U.S. Department  
of Transportation  
**Federal Highway  
Administration**

In Reply Refer To:  
HSSI/WZ-250B

This is in response to your February 10 correspondence requesting the Federal Highway Administration's (FHWA) acceptance of your company's DL1008-SM and SDL1008-SM sign stands as crashworthy traffic control devices for use in work zones and elsewhere on the National Highway System (NHS). Accompanying your letter was the FHWA Office of Safety Design form explaining that the differences between these stands and previously accepted stands was the material of the masts (1-1/4 inch square steel v aluminum). You also noted that change to the mast should have negligible effect because no portion of the stands impacted near the windshield in the original crash tests. You requested that we find these devices acceptable for use on the NHS under the provisions of National Cooperative Highway Research Program Report 350 "Recommended Procedures for the Safety Performance Evaluation of Highway Features."

This enquiry is in regards to our previously accepted portable sign stands DL1008 (WZ-213) & SDL1008 (WZ-250).

**DL1008 - SM**  
for Roll-Up Signs

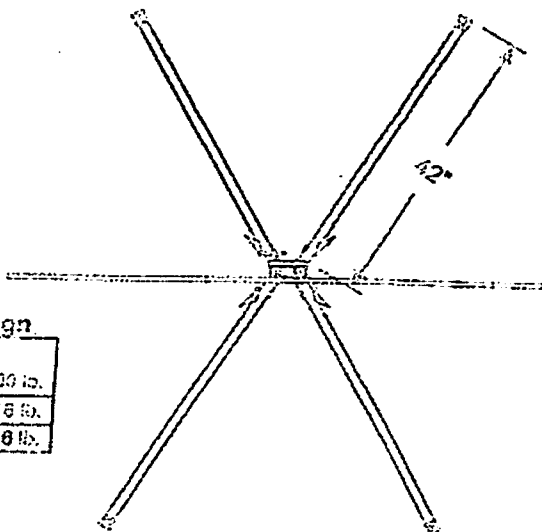
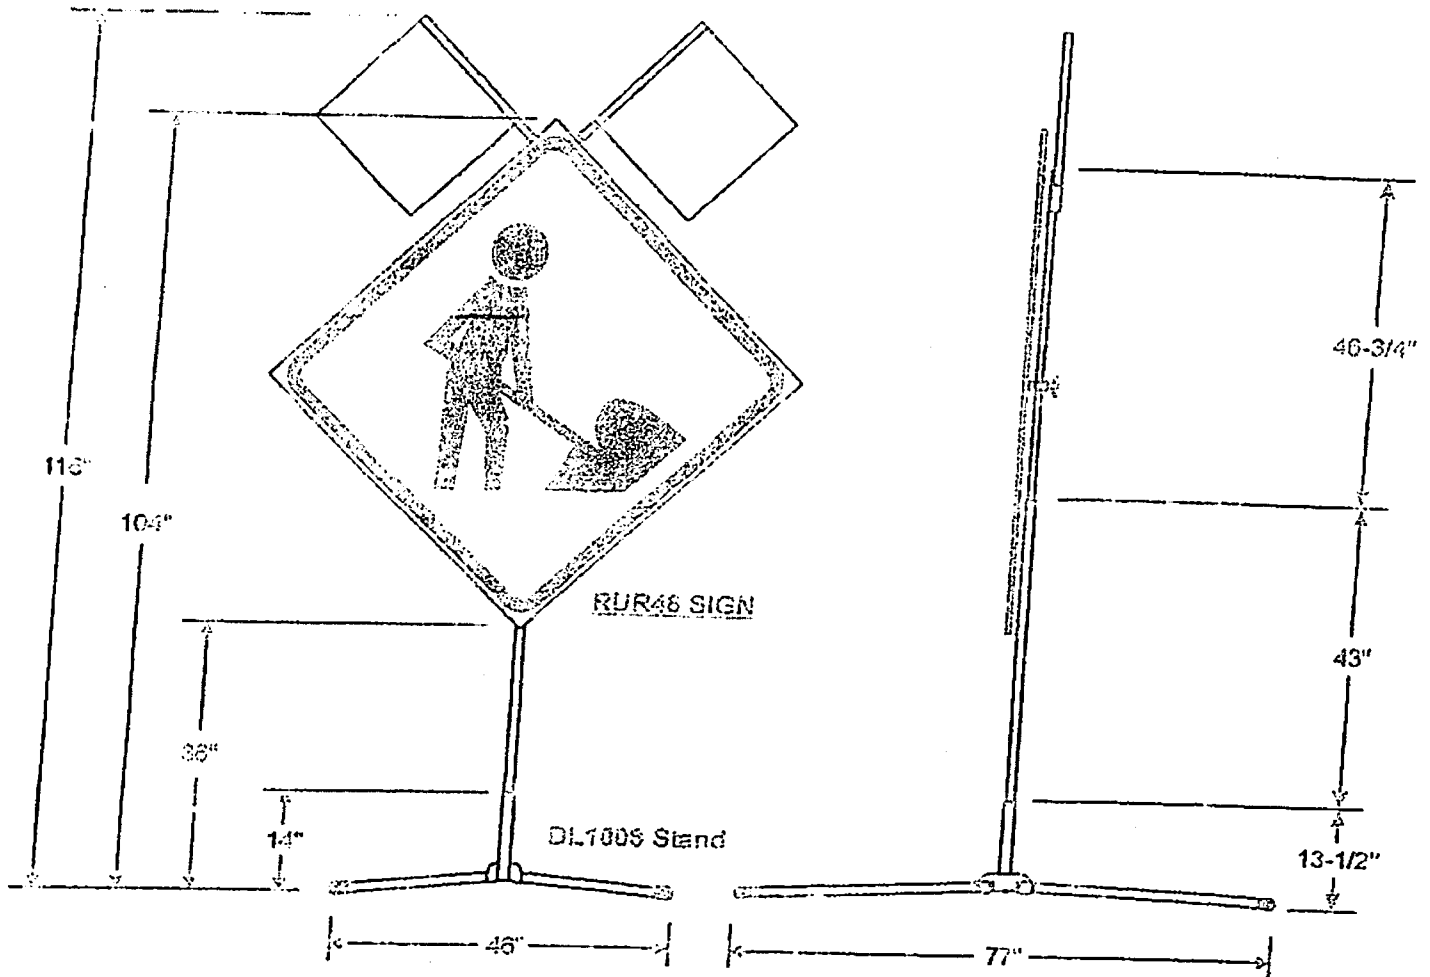
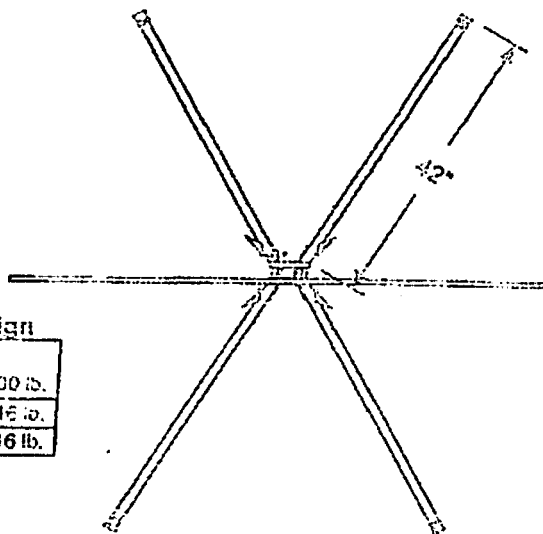
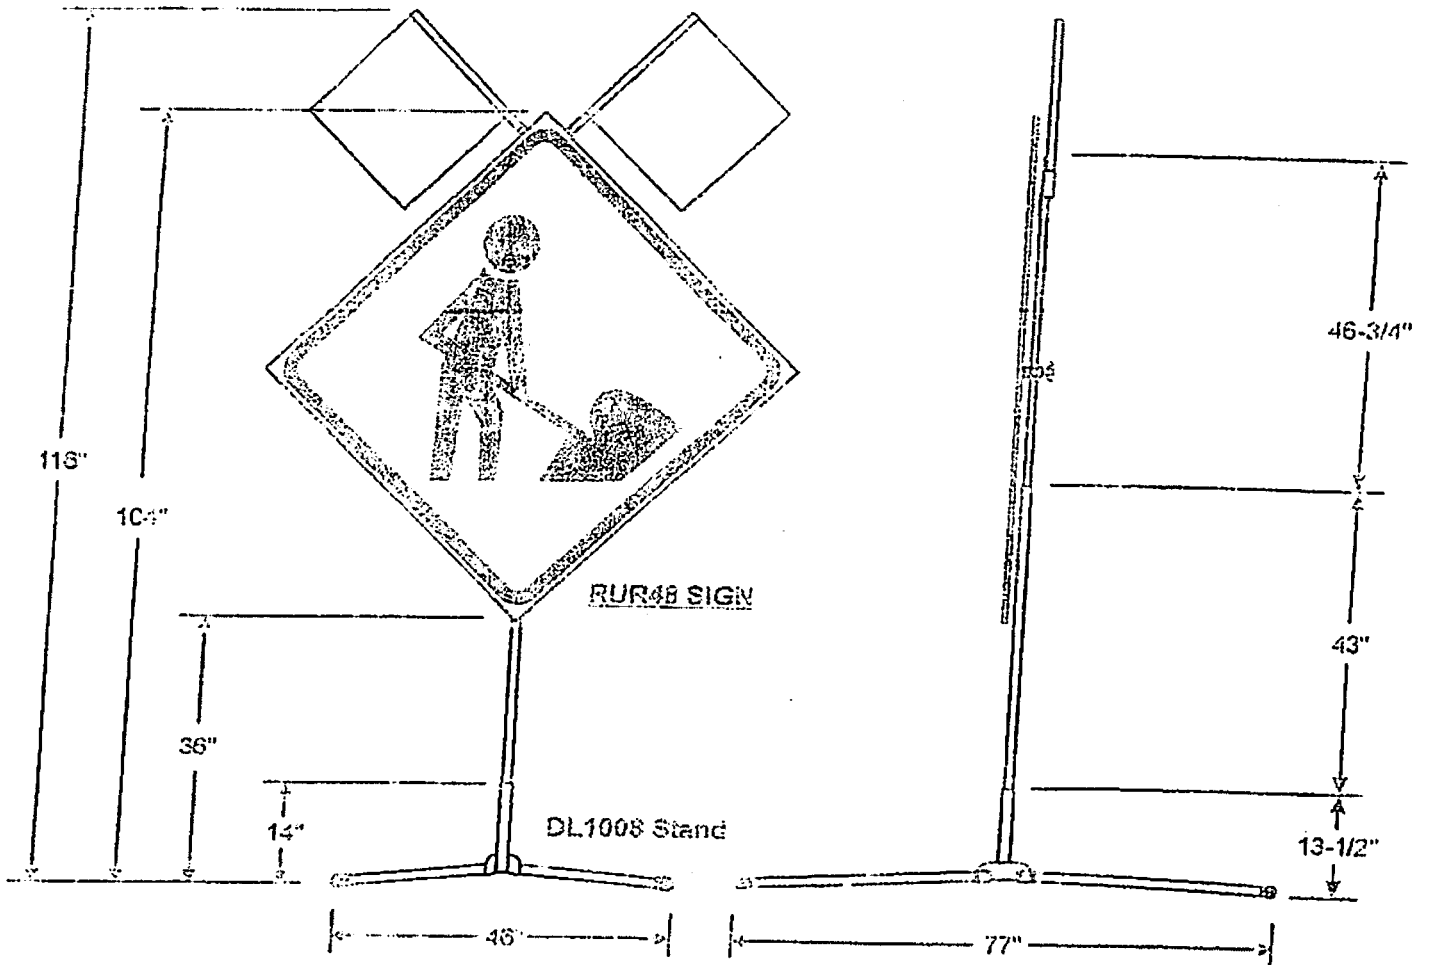
We are seeking acceptance of the DL1008 and SDL1008 with a 1.25 inch x 1.25 inch x 0.10 inch steel mast in place of the current aluminum mast. It is our contention that the slight difference in weight and physical properties of the two mast materials will have a negligible impact on the test results. This is based on the report that stated “no portion of the stand itself impacted near the windshield” during the original test. The new part numbers for these products would be: DL1008-SM and SDL1008-SM.

- Base- Steel, no spring
- Mast- Telescoping 1-1/2", 1-1/4", and 1" sq. ~~aluminum~~ tubing (Steel)  $\Delta$
- Legs- 1-1/4" sq. aluminum legs
